Re: PINNACLE COMMONS, PHASE II, BLDG. 5 (F-20/D26)
9101 Montgomery Bd. NE
Approval of Permanent Certificate of Occupancy (C.O.)
Engineer's Stamp dated 02/14/2000(F-20/D26)
Certification dated 04/25/2005

Re: PINNACLE COMMONS, PHASE II, (F-20/D26)

Re: Pinnacle Commons Grading and Drainage Plan
Engineer's Stamp dated 2-14-00, (F20/D26)

DRAINAGE STUDY FOR PINNACLE COMMON

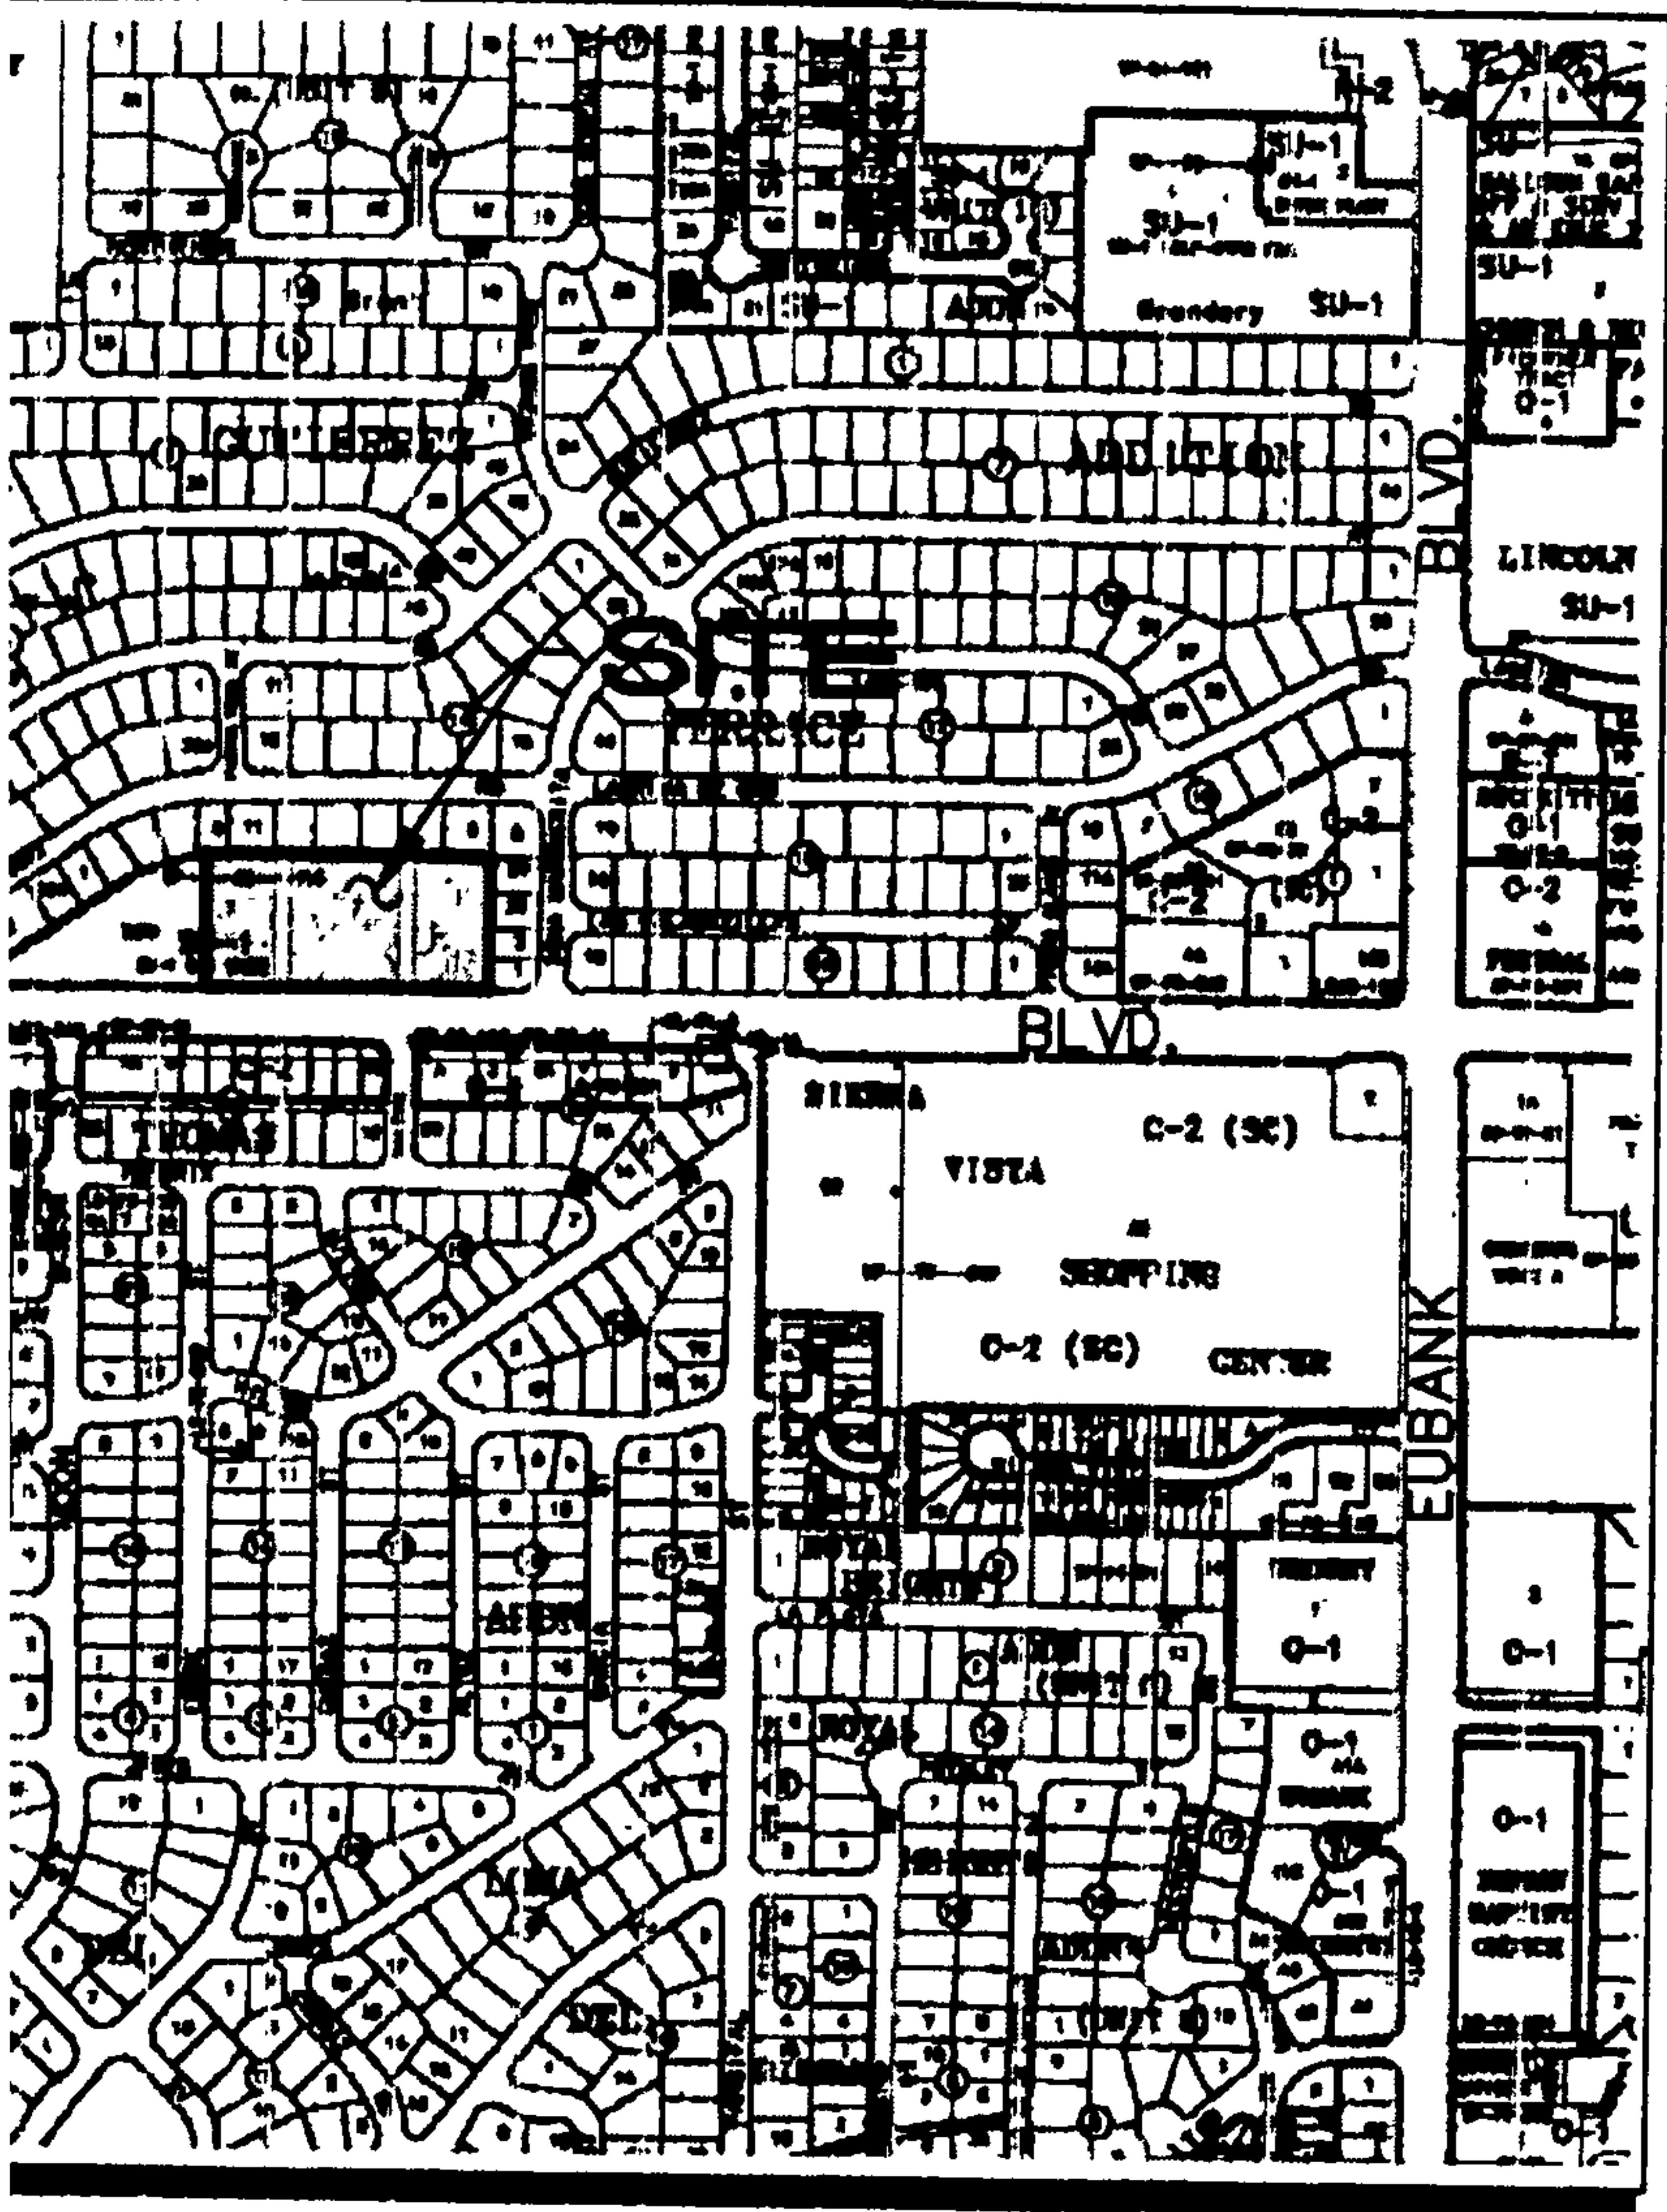
1. The approved Grading and Drainage (G/D) Plan has an Engineer Stamp date of 02/14/2000 not 09/29/2000 as indicated in your submittal. Attached, is a copy of the G/D approval letter, and a copy of the upper right hand corner of the approved G/D Plan.
